V2500-A5 SERIES PROPULSION SYSTEM SERVICE BULLETIN

V2500-ENG-72-0576

ENGINE – TURBINE NOZZLE – PROVIDE A SELECTONE NEW HIGH PRESSURE TURBINE (HPT) 1ST
STAGE VANE ASSEMBLY –

LOCATION OF STAGE 1 HIGH PRESSURE TURBINE VANE ASSEMBLY
FIGURE 1

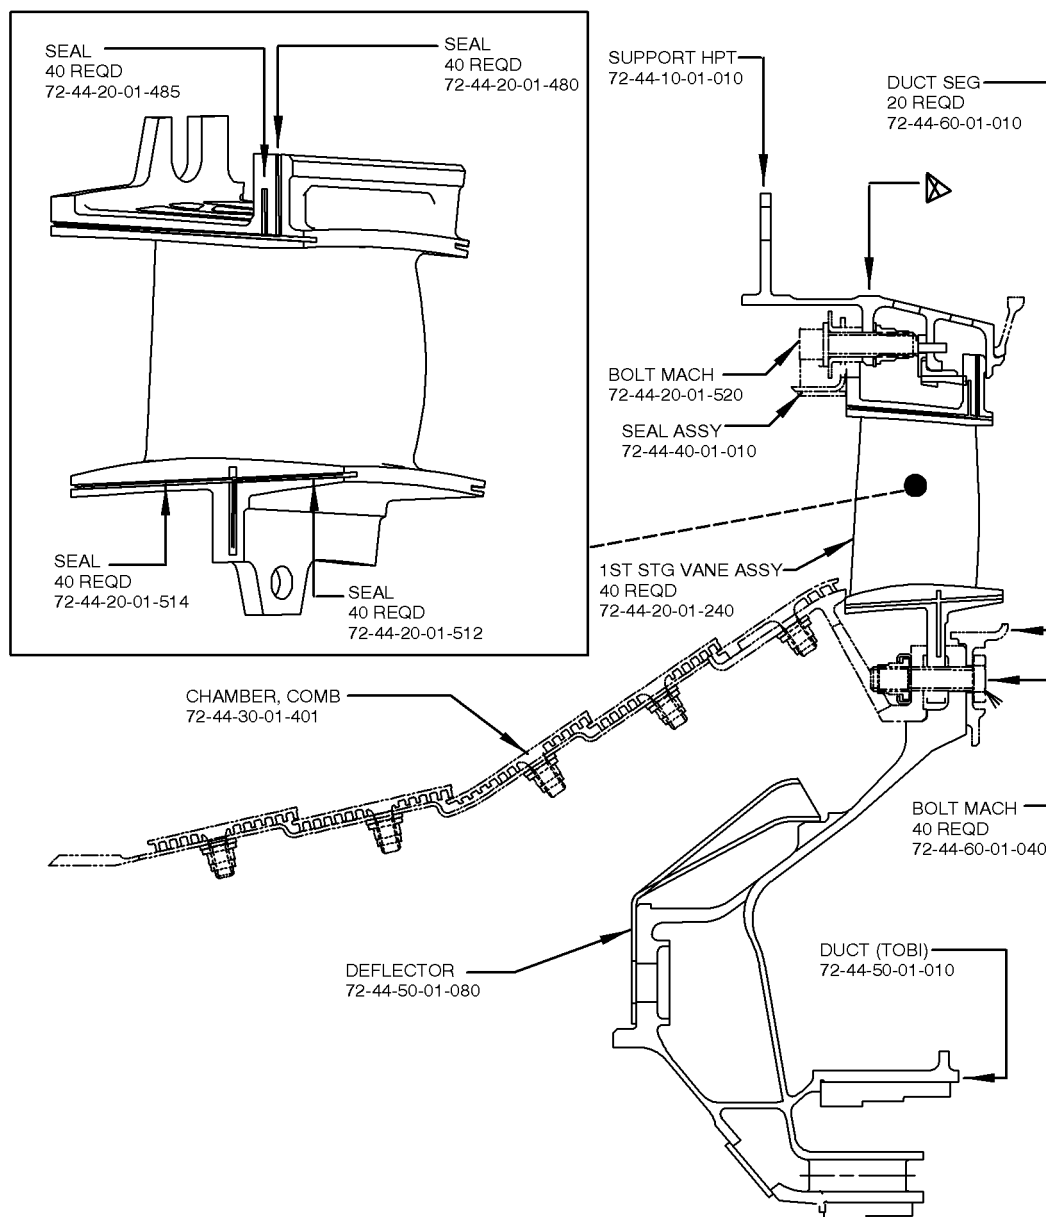
HPT 1st Vane outer platform cracking adjacent to the feather seal slots.

The SelectOne endurance engine V12723 experienced some HPT 1st Vane outer platform cracking adjacent to the feather seal slots.

Redesign the SelectOne HPT 1st Vane by changing the feather seal and slots clearances similar to the A5 1st Vane Design. Issue a Service Bulletin to retrofit V15001 and V15002 to replace 1st Vanes with new design.

Additional feather seal slot depth and width will provide increased clearances similar to the A5 1st Vane design which has successful field experience.

Provide a new HPT 1st Vane to minimize outer platform cracks adjacent to the feather seal.

FAMILY TREE – 1ST STAGE HPT VANE ASSEMBLY REF. CATALOG SEQUENCE NO. 72-44-10
FIGURE 01 ITEM 240
CHART A

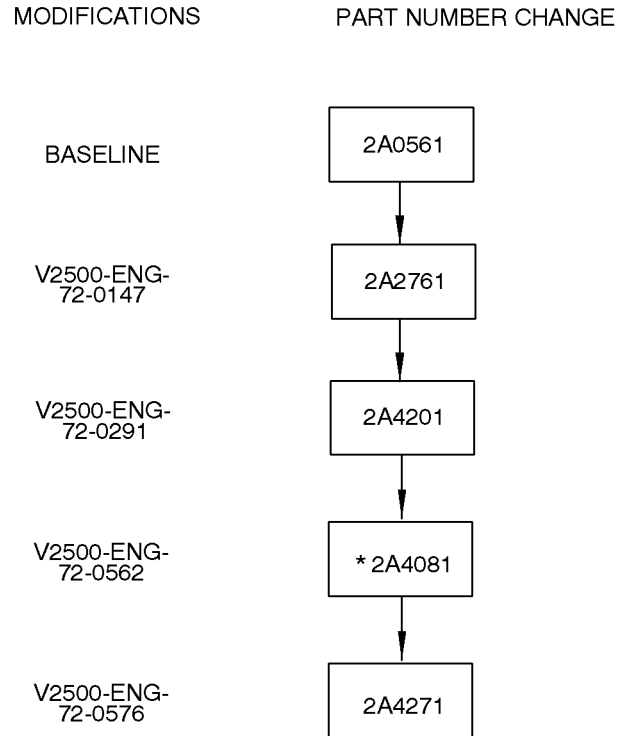
| 01-240 | 2A4271 | 1 | 1st Stage HPT Vane Assembly | - | 2A4081 | (2)(B)(N)(I) |

(2) The new part is an replacement part only, and cannot be obtained by modification of the old part.
